Proposal for Supplement 1 to the 01 series of amendments to Regulation No. 138

I. Proposal

Figure 7b Test procedures for measurement of frequency shift, Method A

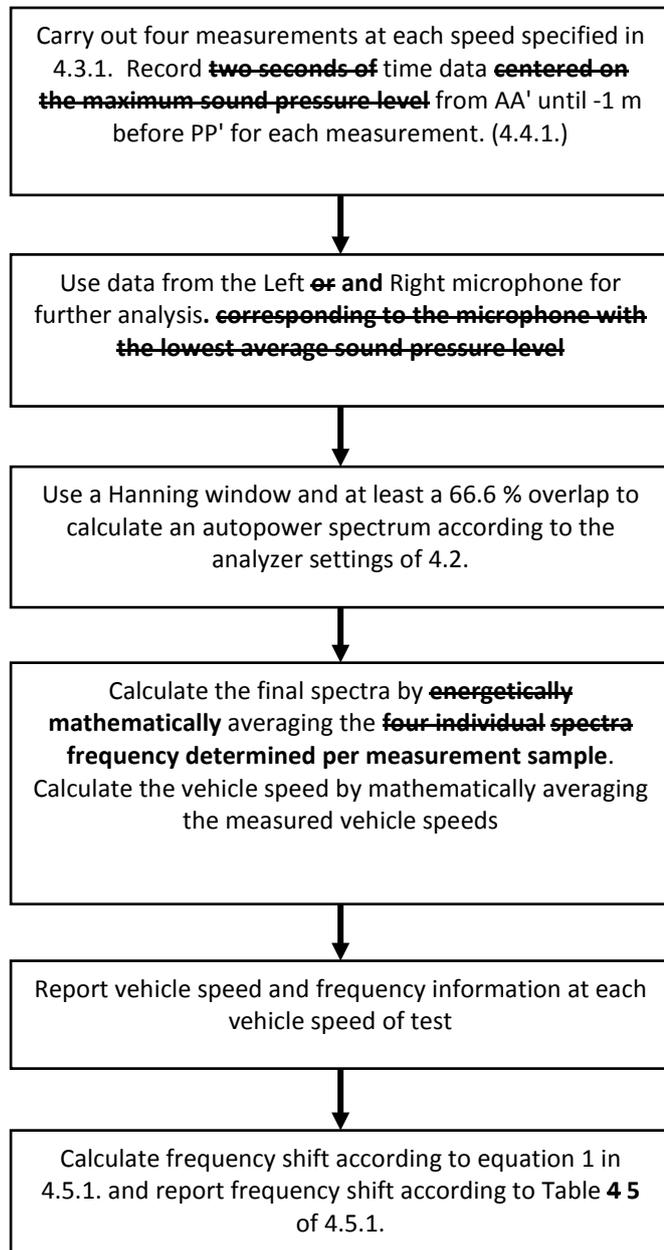
Appendix to Annex 3 Figure 7b, amend to read:

A3 App. The flowcharts have been amended to reflect the regulation text.

Test procedures for measurement of frequency shift, Methods B, C, D, and E

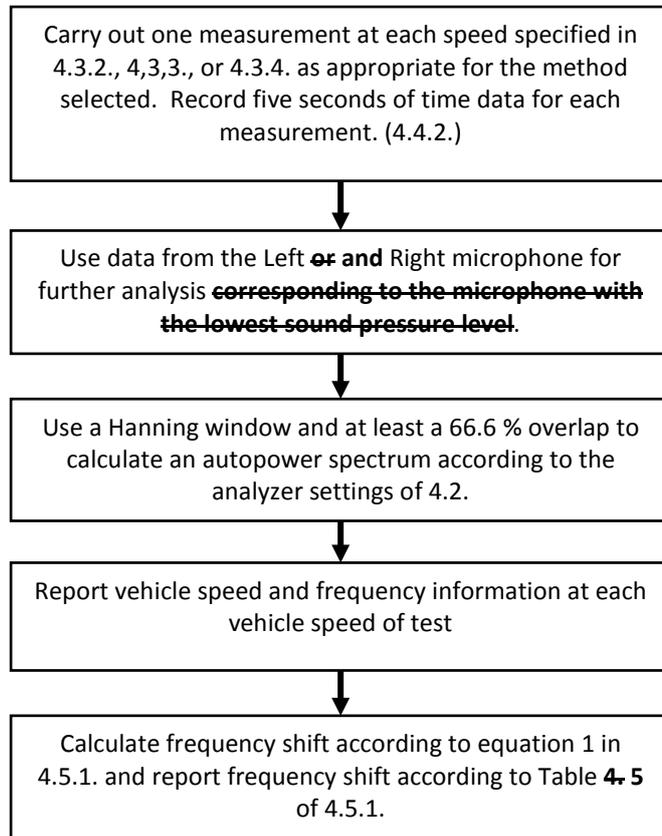
Appendix to Annex 3 Figure 7c, amend to read:
